# Proposed Selwyn District Plan

# Section 42A Report

Report on submissions and further submissions

**Ecosystems and Indigenous Biodiversity**

Figure 1: SNAs identified by CRC:

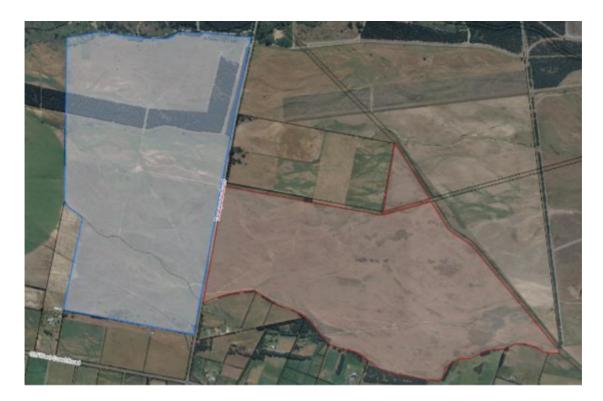
DPR-0260	CRC	102	ECO- SCHED4	Support In Part	Add the area outlined in red in Figure 1 of the Ecological Assessment of Environment Canterbury Long-Term Lease Land, Thompsons Road, West Melton (February 2019) to ECO-SCHED4.
DPR-0260	CRC	103	ECO- SCHED4	Support In Part	Add the area outlined in blue in Figure 1 of the Ecological Assessment of Environment Canterbury Long-Term Lease Land, Thompsons Road, West Melton (February 2019) to ECO-SCHED4.
DPR-0260	CRC	104	ECO Significant Natural	Support In Part	Add the area outlined in red in Figure 1 of the Ecological Assessment of Environment Canterbury Long-Term Lease Land, Thompsons Road, West Melton (February

- 16.11 As outlined in his evidence (**Appendix 3**), Dr Lloyd agrees that the sites meet the ecological significance criteria in ECO-SCHED1 and that they warrant inclusion in ECO-SCHED4 and in the ECO Significant Natural Areas Overlay. I therefore recommend that the submission points be accepted. These amendments will also partially address the concerns raised by DOC<sup>255</sup>, and I recommend that their submission point be accepted.

- 16.17 I recommend, for the reasons given above, that the Hearings Panel add the areas shown blue and red in Figure 1 above as SNAs to ECO-SCHED4 and and in the ECO Significant Natural Areas Overlay as shown in **Appendix 2** to recognize that the protection of these areas is a matter of national importance.
- 16.18 It is recommended that submissions and further submissions are either accepted, accepted in part or rejected as shown in **Appendix 1**.
- 16.19 The scale of change does not require a s32AA evaluation.
